# CONVAIR

## COMMERCIAL CHANGE PROPOSAL

MODEL: 30-5 (Convair "600")

TITLE Specification Administrative Change (Flight and Navigational Instruments - Interconnecting, Revision of)

MODEL 600 CARGO COMPARTMENTS  
COP #17A- INFORMATION SKETCH  
(NOT A PART OF SPECIFICATION LANGUAGE)

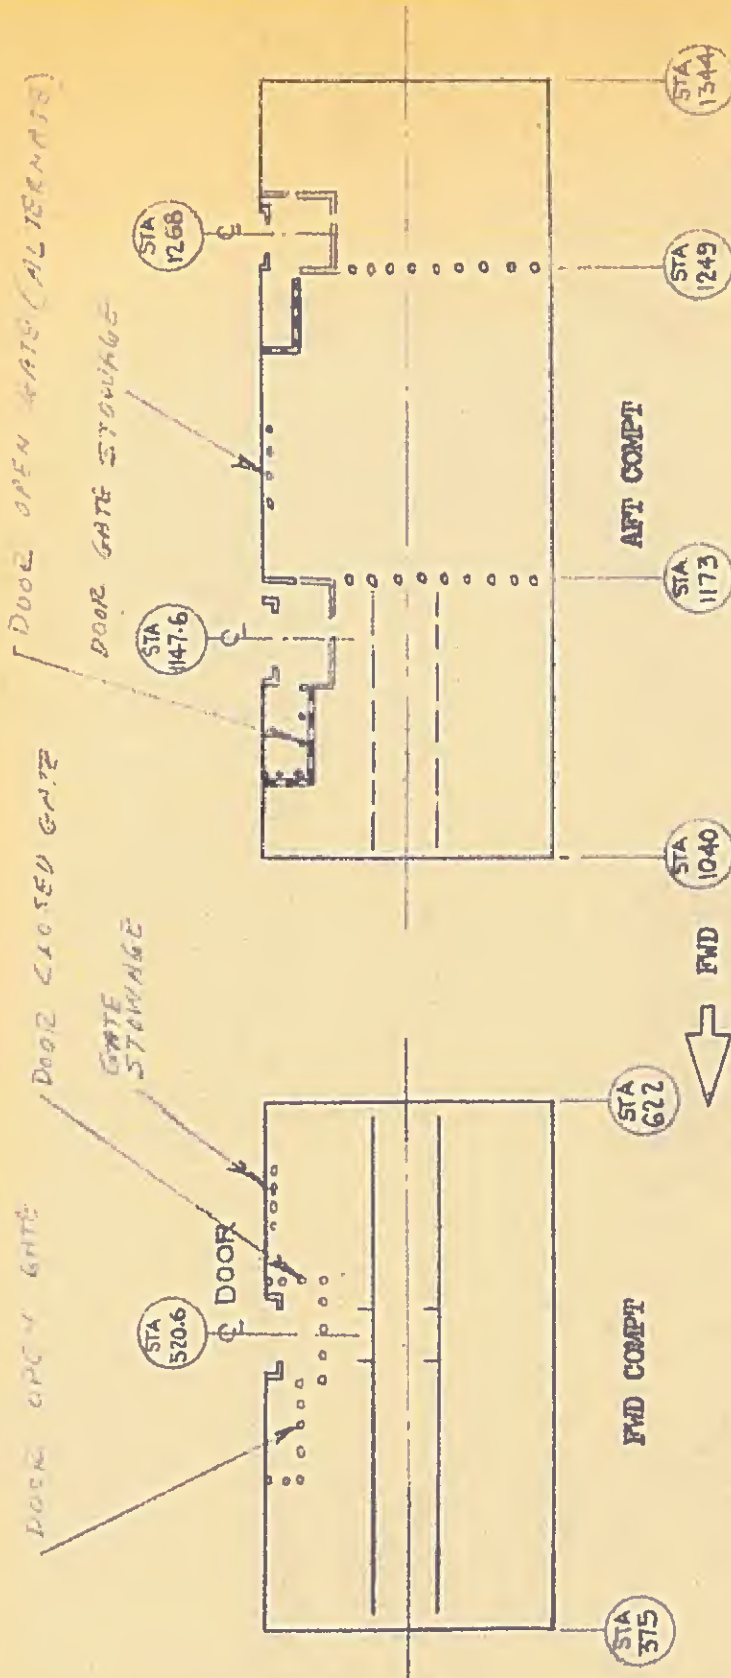
Paragraph 3.1.2.2 - TYPICAL LOADING SUMMARY will be revised to reflect cargo weight totals using weight figure of 12 lbs per cu ft density in a future specification revision after Customer acceptance of this proposal.

The design and operating objectives shall be in accordance with Attachment to Convair Letter No. 10-0-1767 (revised 2 June 1959).
